# KIRKMAN SHOPPES PLAT

## SUMMARY

Minor Plat request for the redevelopment of the Kirkman Shoppes shopping center.

**Updated:** October 31, 2013

## PROPOSED PLAT

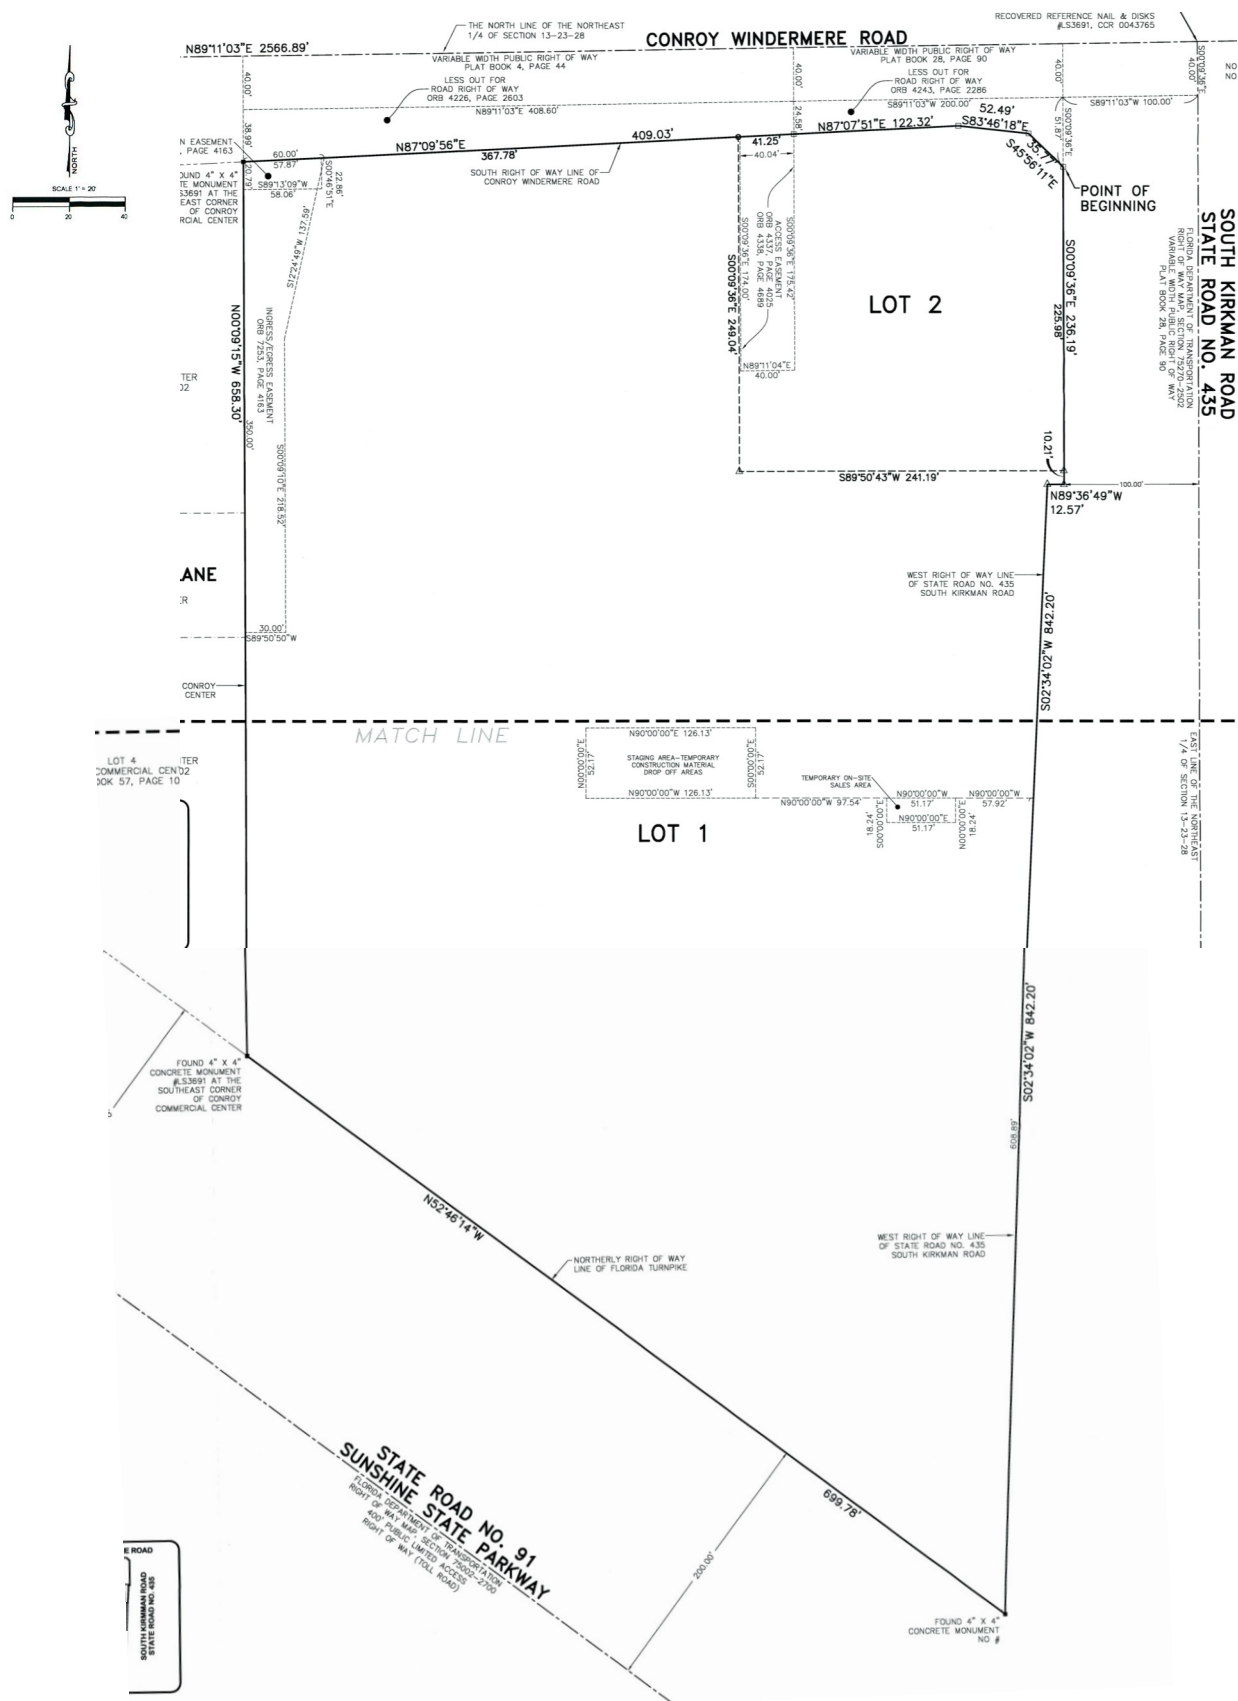
1. Plat— Minor. Plat Face Changes - There are a number of changes required to the face of the plat. In addition to the changes required on the plat, the following is a list of additional requirements.

- 1) Changes to the face of the plat.( A copy has already been returned to the surveyor).
  - 2) Recording Fees (Checks should be made payable Orange County Comptroller.)

1. The applicant revises the plat to satisfy the conditions in this report.
2. The plat is scheduled for City Council.
3. The plat is recorded with the Orange County Comptroller.

## DEVELOPMENT PLAN (BOTH LOTS)

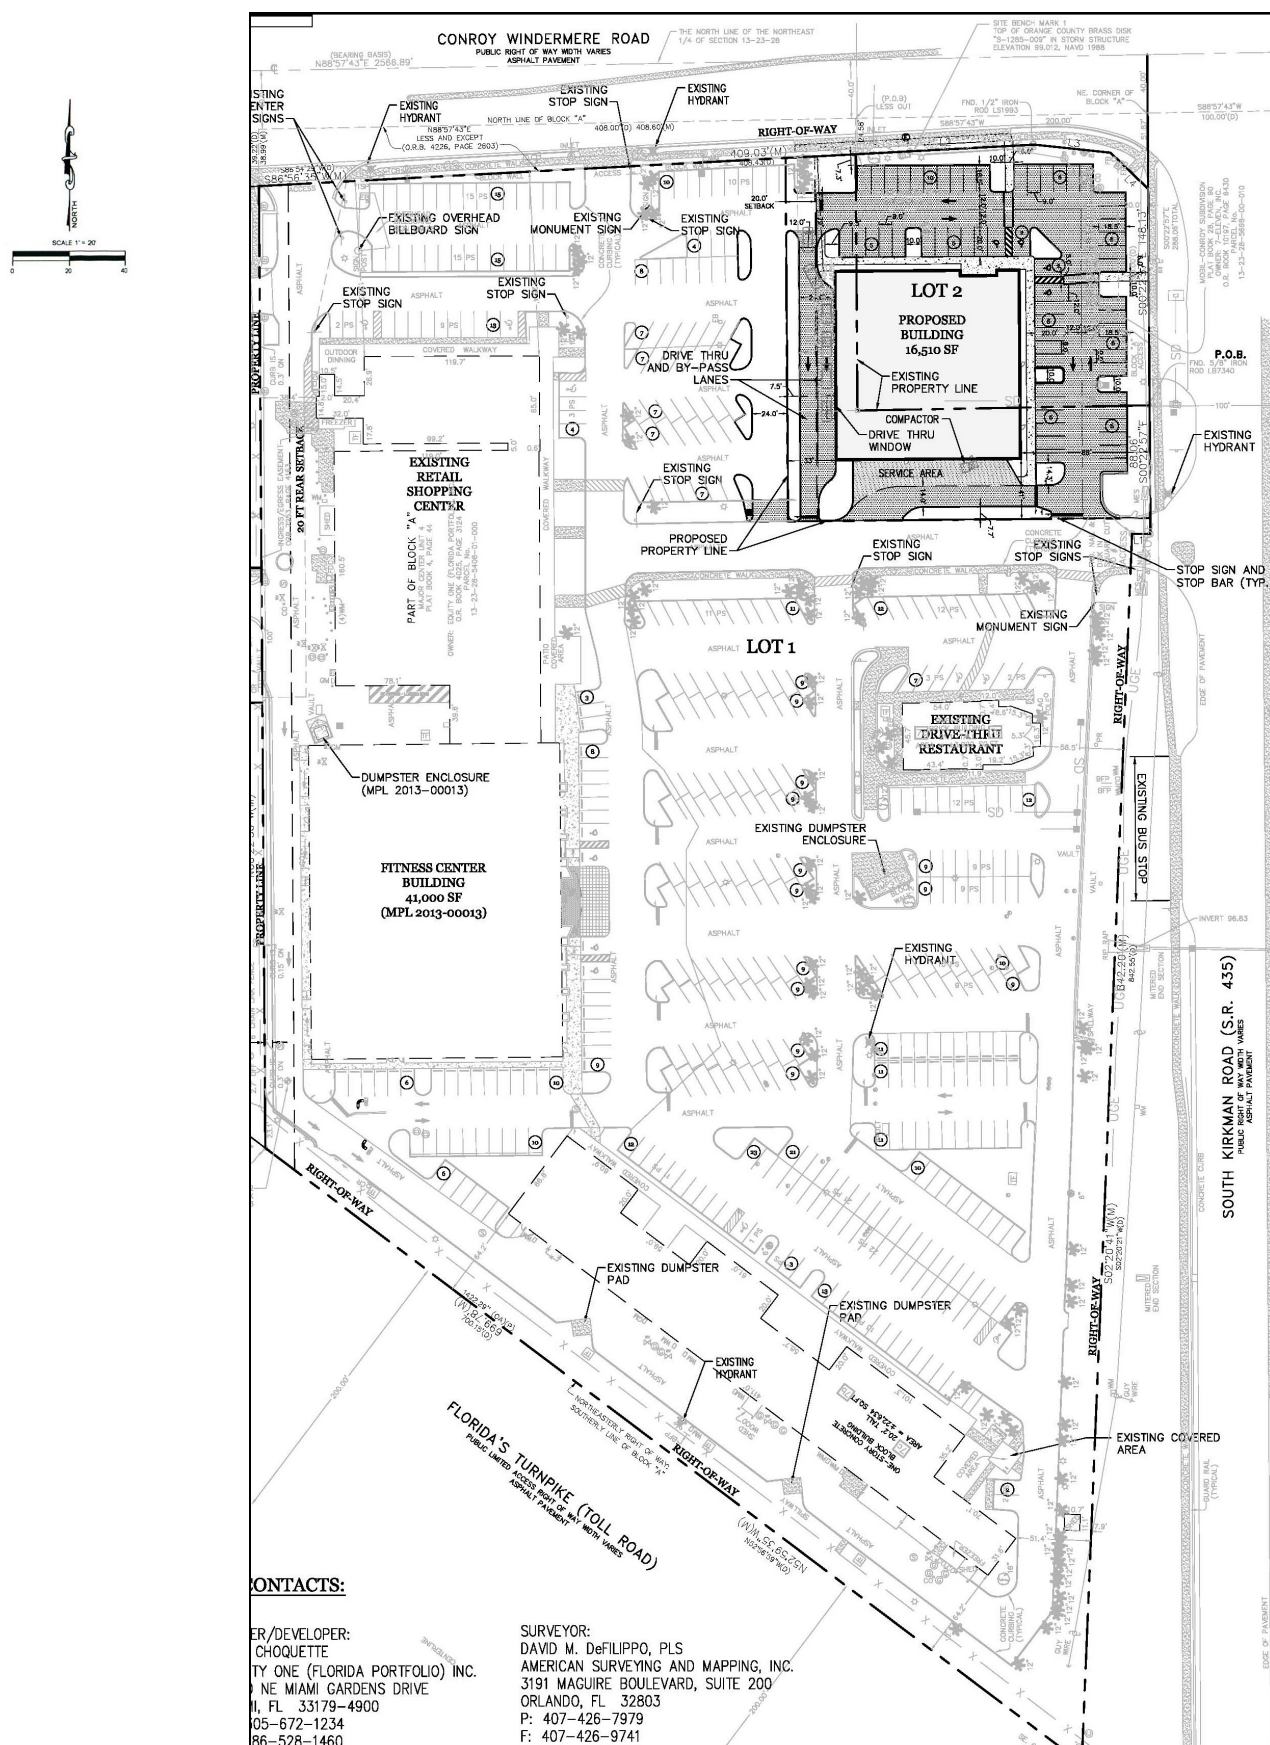
1. Cross Access Corridor. The subject property is adjacent to a major thoroughfare, Kirkman Road. Orlando Land Development Code (LDC), Chapter 61 (Sections 61.108 - 61.113), provides the minimum requirements for cross-access corridors. A cross access easement shall be located on the southern property boundary of lot two (2) on the face of the replat. The cross access easement location shall correlate to those shown on with MPL2013-00032 and CUP2013-00013.
